City of Concord, New Hampshire
Architectural Design Review Committee
October 1, 2024 Minutes

- 6.1 Dundee Investment Associates, LLC, requests an architectural design review recommendation for an amendment to a major site plan and a conditional use permit application for the construction of a 3,404-square-foot building, two side-by-side drive-thru lanes, and associated site improvements at 287 Loudon Rd in the Gateway Performance (GWP) District. (2024-069) **NOTE: Signage is not being reviewed as part of this request and will be reviewed with required sign permits prior to issuance of a certificate of occupancy per Section 16.03(11) Signs of the Site Plan Regulations. Application materials at that time shall fully comply with Article 28-9-4(f)(3) Submittal Requirements and Article 28-6 Sign Regulations of the Zoning Ordinance.**

CUTSHEET
One Love Heart (XL)

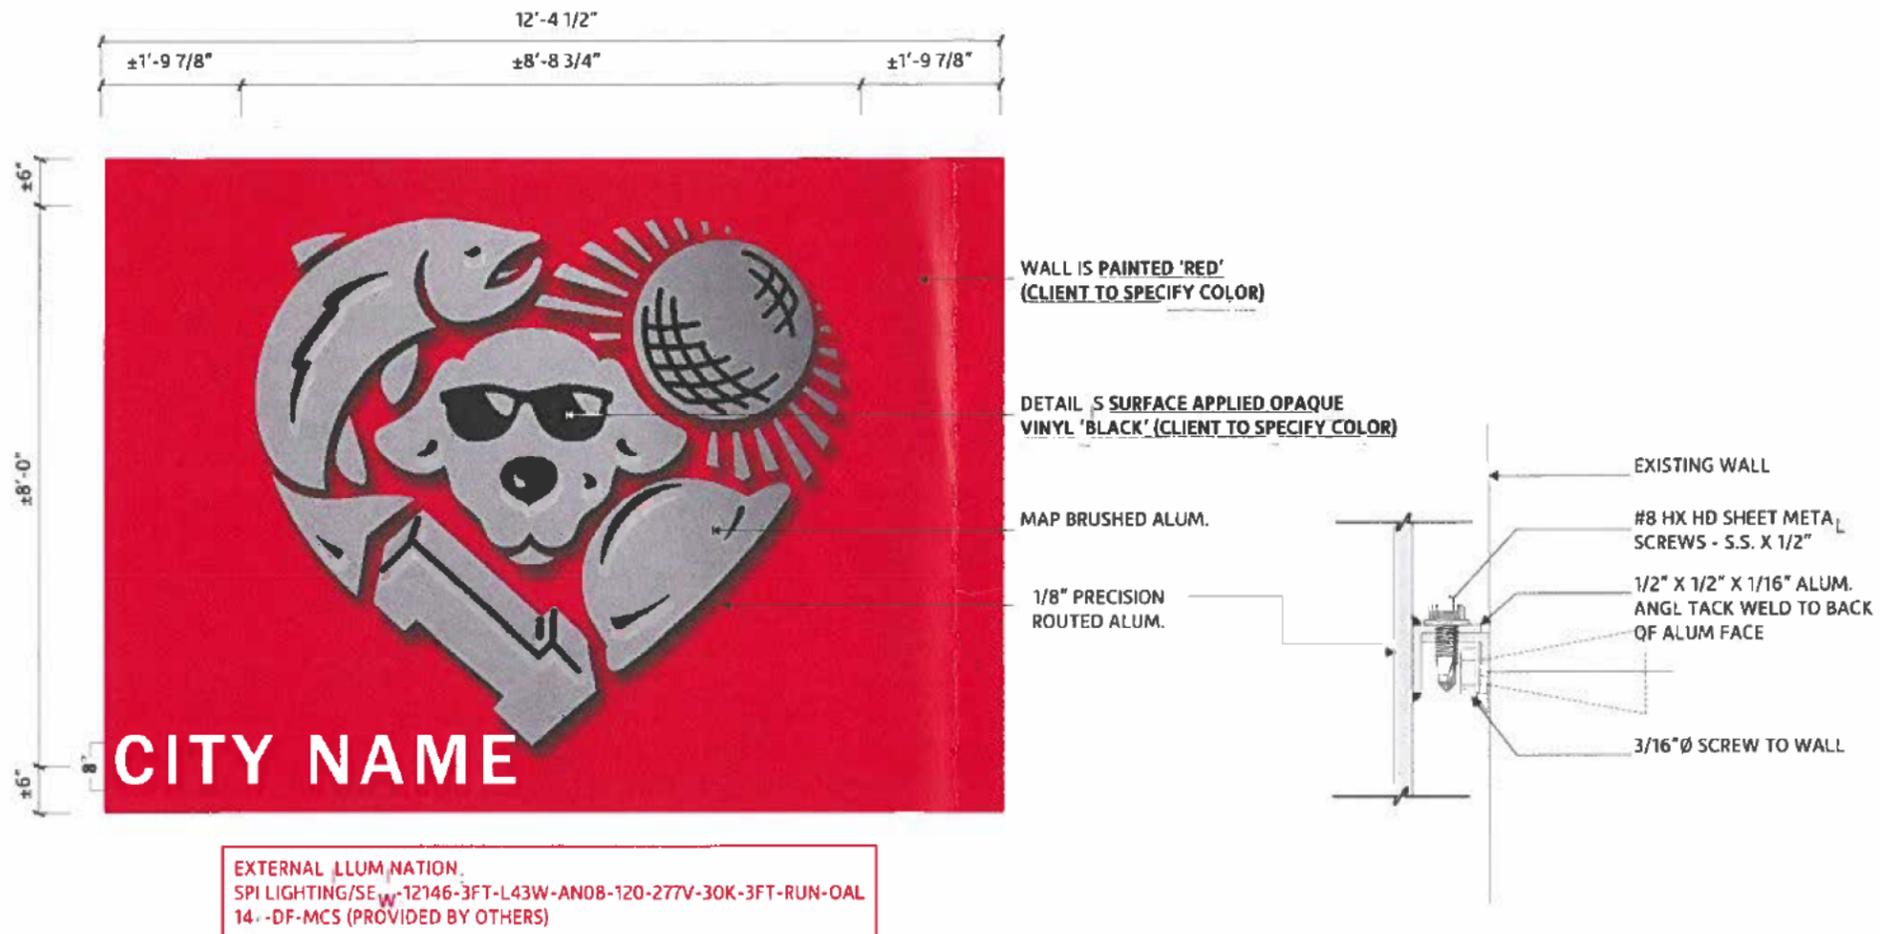
Mr. Johnston stated they do have an alternate version they use to replace the mural with the one heart which has more of their story. It is attached to the wall and sticks out a little bit. Mr. Johnston asked the ADRC if this would be more in line with what they would consider artwork for the building.

Co-Chair Hengen stated the artwork looks abstract and does not read as a sign.

Mr. King asked that they update what they will present to Planning Board to represent the changes to remove the Cane mural with the one love artwork.

- The One Love Heart (XL) artwork shared by the applicant during the October 1, 2024, Architectural Design Review meeting, and attached as Exhibit A to these minutes, shall be used in place of the proposed Cane’s sign on the front elevation.
